Public comment response

January 2, 2026

Re: Project File #608020 Cape Cod Bridges Project

Figure 2 - Location of proposed overpass versus existing path plan

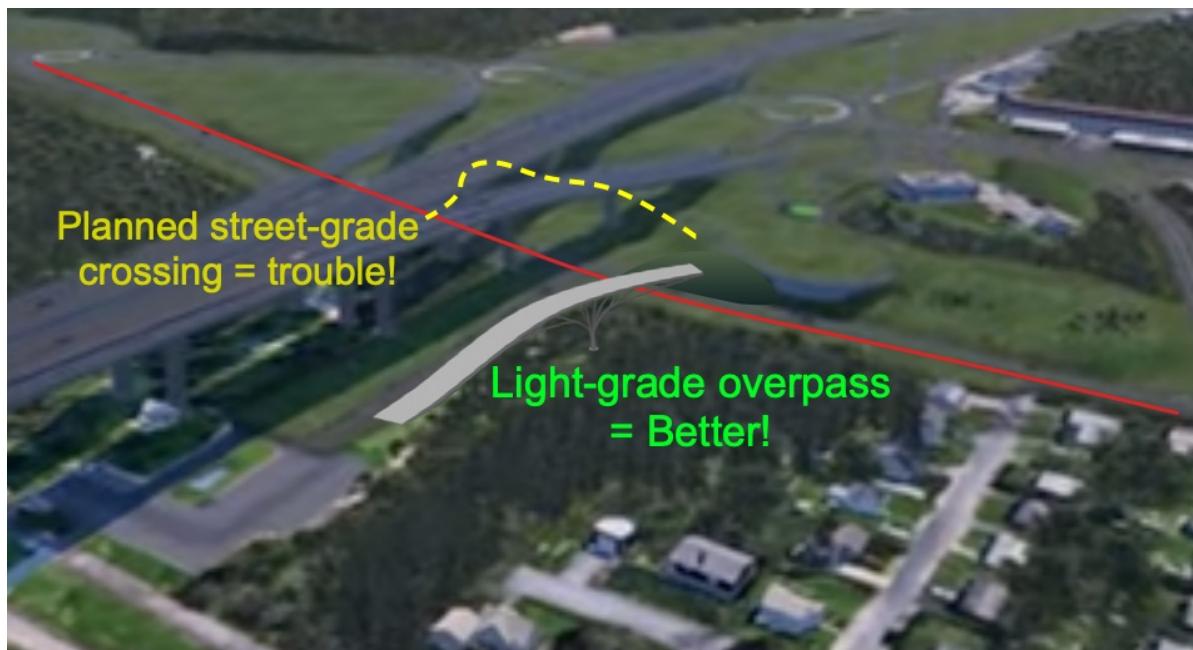
A light, ramped, grade-separated bike & walker overpass is a simple cost-effective solution that **eliminates the problems entirely**. An overpass can leverage existing site elevation and the already-planned retaining wall to descend towards the canal into the Bourne Recreational Area. Figure 2 illustrates this.²

This overpass constitutes a reasonable design alternative that meets the project's purpose and need while reducing adverse effects on both the human and natural environment. The benefits are clear:

Figure 3 - Descent grade eliminated

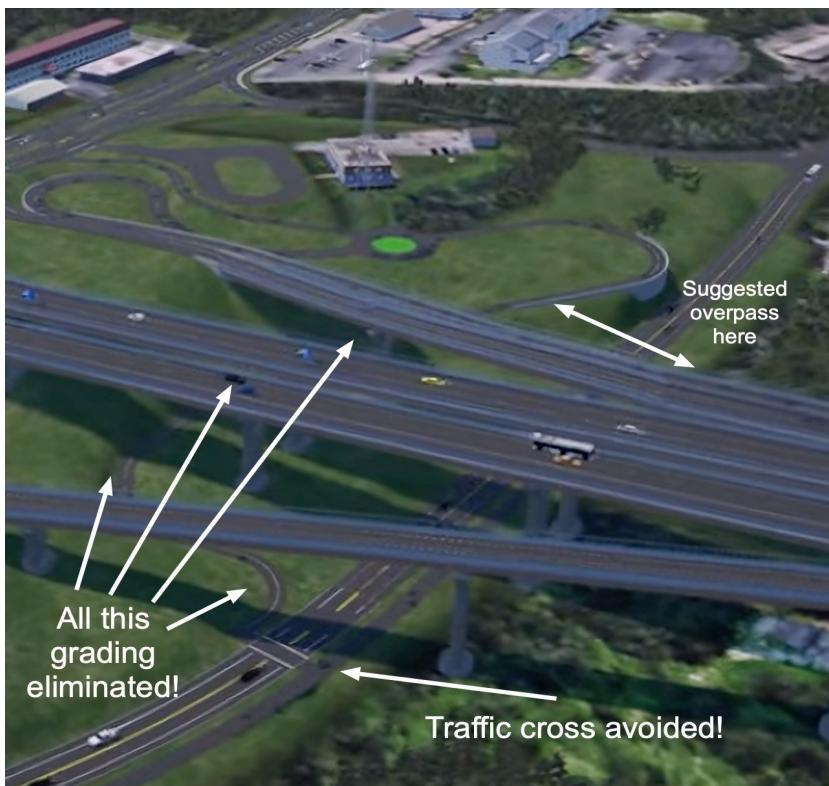
- **Improves safety unequivocally.** The overpass entirely removes the interaction between bikes, walkers and drivers.
- **Further encourages usage.** Eliminating fear of car collisions makes all users happier, resulting in increased year-round use by locals and visitors.
- **Better supports event surges.** Large-scale events can proceed without closing the road or requiring law enforcement control. Smaller events will be feasible because hiring police traffic control will not be needed.
- **Simplifies canal bike path connection.** The overpass can safely exit near most users' destination - the bike path.
- **Improves site impact.** Utilizing existing right-of-way maintains land alignment, leverages the descending elevation, and eliminates extra berms and erosion control.

existing Bourne Recreation Area and Cape Cod Canal District property. No property taking is required. See rough placement illustrated in Figures 3 & 4.

Figure 4 - Descent Ramp into Bourne Recreation Area

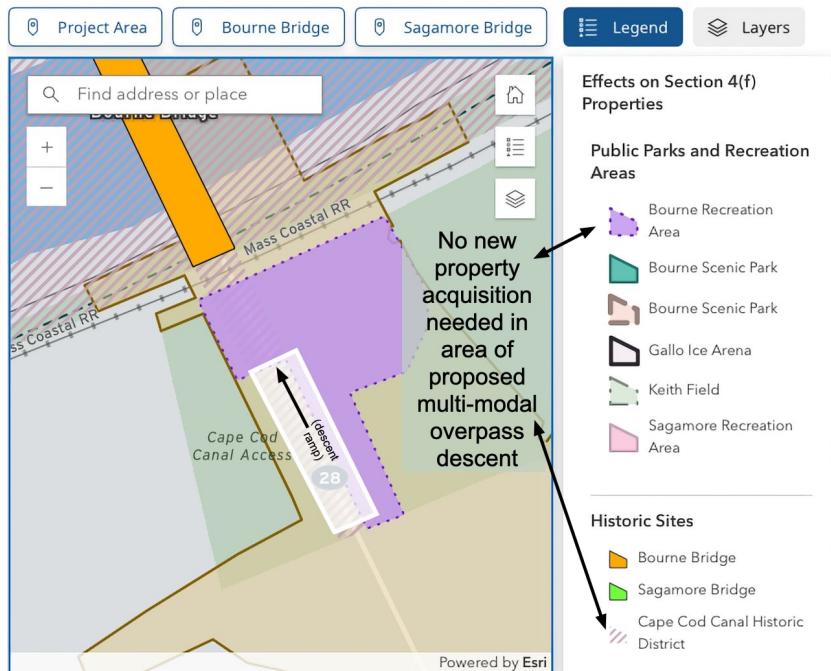
- **The change leverages planned structures.** A structural berm and major path descent are already included in the current plan; these elements can be reworked to form the southerly approach to an overpass. The actual overpass can be a light, non-vehicular structure.
- **No new property required.** The northern side of the overpass, which constitutes the descent over grade, can descend into the
